**TSG-RAN Meeting #14  
Kyoto, Japan, 11 - 14, December, 2001**

**TSGRP#14(01) 0851**

**Title: Agreed CRs to TS 25.415**

**Source: TSG-RAN WG3**

Figure 9: Successful Initialisation of Iu UP for m RFCIs

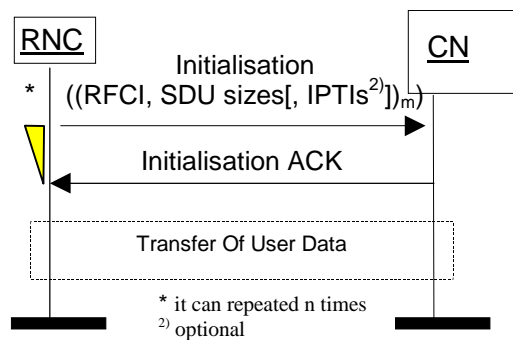
<b>Reason for change:</b>	⌘ In RAN3#23 it was agreed to exclude the “No_Data” mode from the first RFC in the initialisation frame.  However, according to TS26.093, the first frames to be sent after Iu UP initialisation shall have TX_TYPE 00. This TX_TYPE corresponds to speech frames and can therefore only be mapped onto a FRAME_TYPE comprised between 0 and 7. Hence, the RFC AMR SID corresponding to FRAME_TYPE number 08 of the AMR codec when Source Controlled Rate operation is allowed, shall not be allowed for the first RFC of the Iu UP initialisation frame.
<b>Summary of change:</b>	⌘ SID is banned as first RFC in the INIT frame. <u>Impact analysis</u>  Impact assessment towards the previous version of the specification (same release):  This CR has [no impact] with the previous version of the specification (same release) with the assumed previous interpretation since it is in line with all stage 2 specifications.

Figure 9: Successful Initialisation of Iu UP for m RFCIs

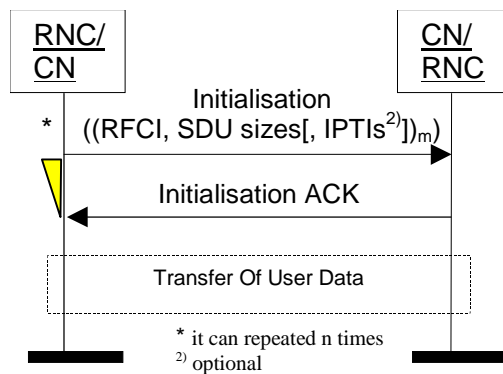
<b>Reason for change:</b>	⌘ In RAN3#23 it was agreed to exclude the “No_Data” mode from the first RFC in the initialisation frame.  However, according to TS26.093, the first frames to be sent after Iu UP initialisation shall have TX_TYPE 00. This TX_TYPE corresponds to speech frames and can therefore only be mapped onto a FRAME_TYPE comprised between 0 and 7. Hence, the RFC AMR SID corresponding to FRAME_TYPE number 08 of the AMR codec when Source Controlled Rate operation is allowed, shall not be allowed for the first RFC of the Iu UP initialisation frame.
<b>Summary of change:</b>	⌘ SID is banned as first RFC in the INIT frame.  Impact Analysis: This CR has no impact with the previous version of the specification (same release) with the assumed interpretation of the previous version since it is in line with all stage 2 specifications.
<b>Consequences if not approved:</b>	⌘ Error handling due to impossibility to derive a comfort noise.

Figure A.1

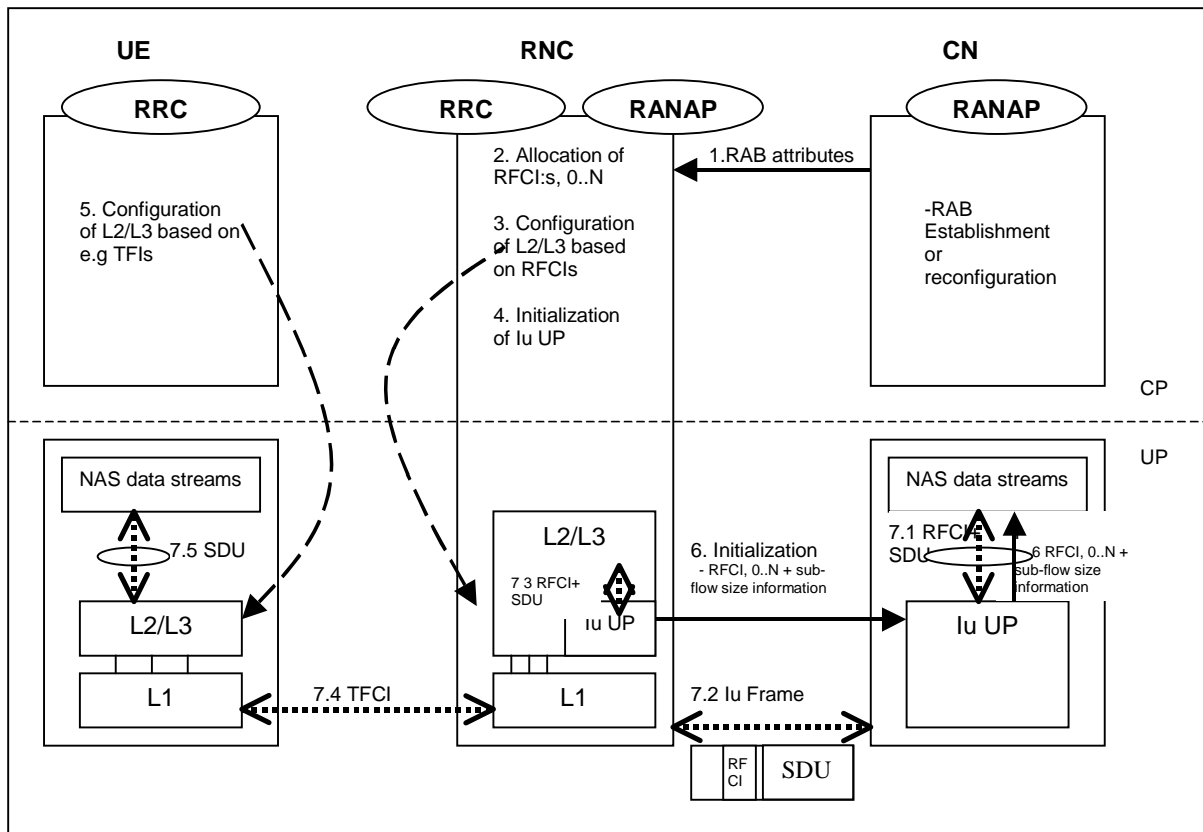
<b>Reason for change:</b>	⌘ The Annex A has wrong information on the number of bits for AMR rate 4.75kbit/s (see e.g. table 6-2 in 26.102v3.3.0).
<b>Summary of change:</b>	⌘ To correct the number of bits for the AMR rate 4.75kbit/s.
<b>Consequences if not approved:</b>	⌘ If this CR is not approved the Annex A contains misleading and incorrect information.  <u>Impact analysis</u>  Impact assessment towards the previous version of the specification (same release): This CR has no impact since Annex A is only informative, and should not have direct impact on the implementations.

Figure A.1

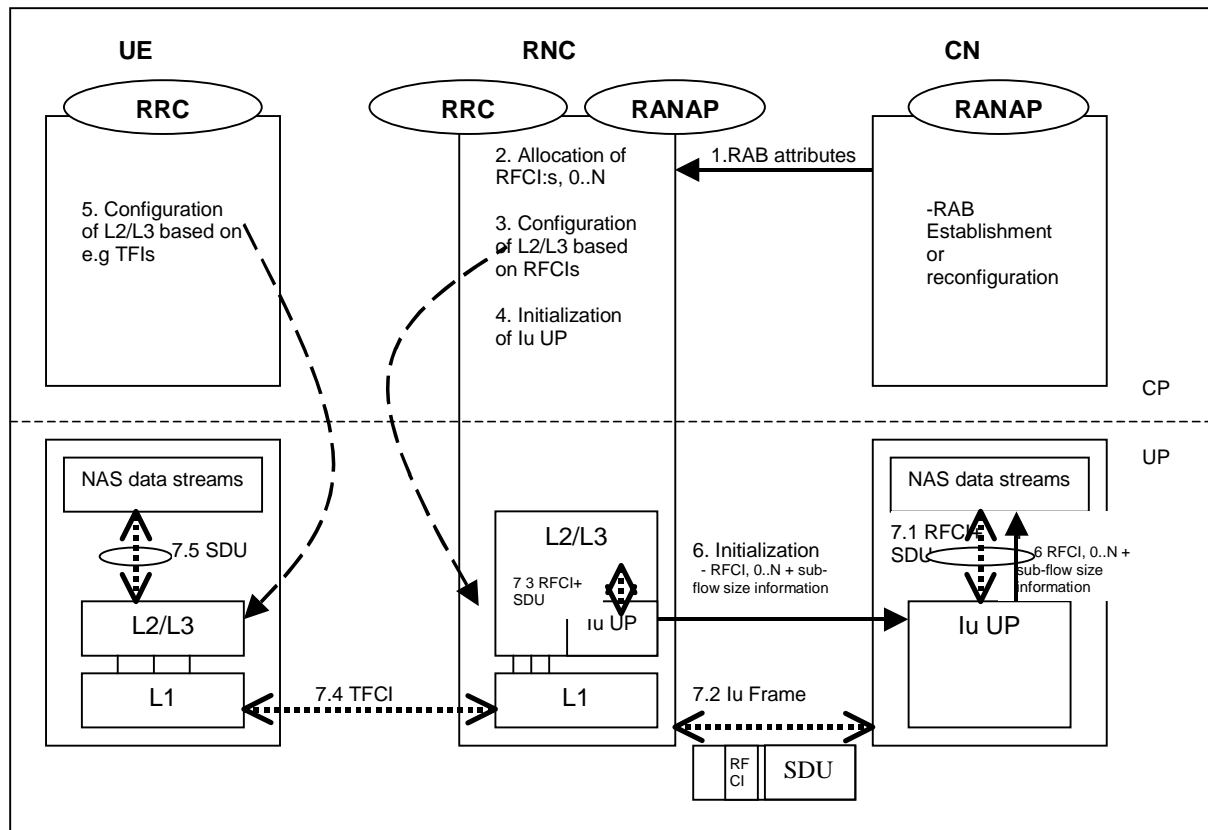
<b>Reason for change:</b>	⌘ The Annex A has wrong information on the number of bits for AMR rate 4.75kbit/s (see e.g. table 6-2 in 26.102v4.0.0).
<b>Summary of change:</b>	⌘ To correct the number of bits for the AMR rate 4.75kbit/s.
<b>Consequences if not approved:</b>	⌘ If this CR is not approved the Annex A contains misleading and incorrect information.  <u>Impact analysis</u>  Impact assessment towards the previous version of the specification (same release): This CR has no impact since Annex A is only informative, and should not have direct impact on the implementations.  Compatibility Analysis towards previous release: This CR is compatible since Annex A is only informative, and should not have direct impact on the implementations.
